# Electrical Safety Audit Report

**Bank Ltd.**

**SAS Powertech Pvt Ltd.**

**Audit Period: 2018**

### Site Photographs:

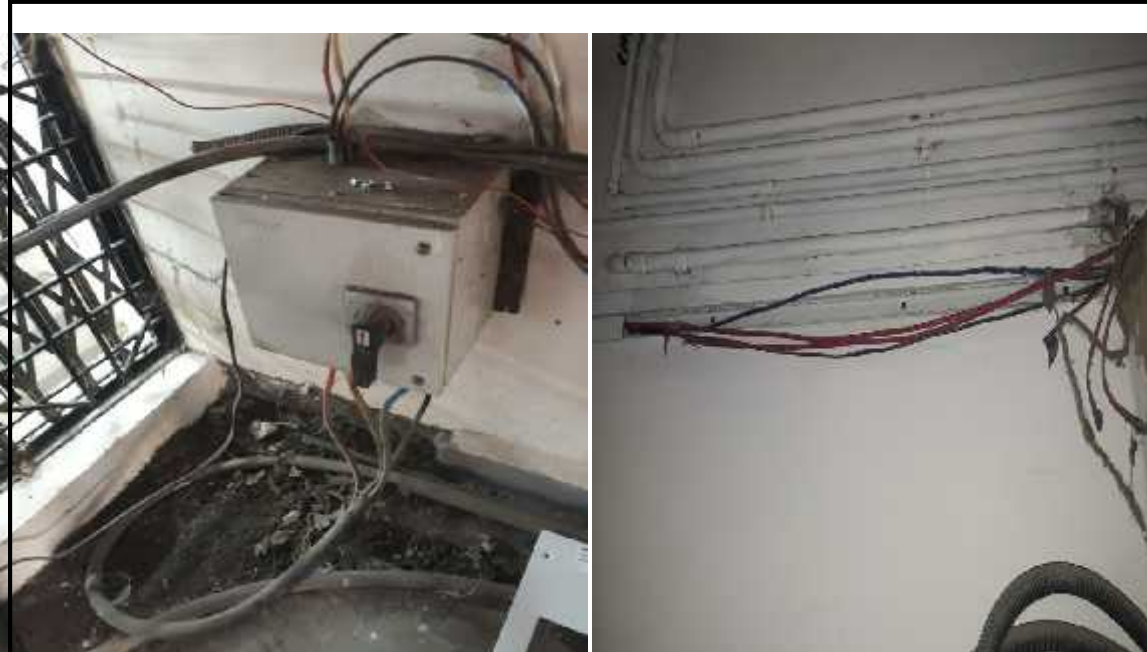
Rubber Mats are not provided in front of LT panels. Main electrical input cables are not terminated and secured properly.

DG change over switch is mounted on wall and cabling is improper. There is possibility of damage due to rodents. Inside some cables are brought out of casing capping are joined improperly.

UPS installed for Branch & ATM are well protected & are not accessible for layman. Provision should be made for hydrogen exhaust using exhaust fans.

Distribution Boards & Fuse units are installed on wooden board which may catch fire during fault. It is recommended to use metal DB in place of existing wooden board.

Main DB and changeover switch at ground floor are installed above underground water storage tank. This tank frequently overflows. This is a potentially dangerous situation. Corrective actions should be taken to keep this place dry to lower a risk of electric shock or electrical incident.

This is the pole from which bank LT electric supply is tapped. The joints at present are in good condition. This overhead line is property of MSEDCL and may get tapped for other consumers and there is possibility of neutral failure.
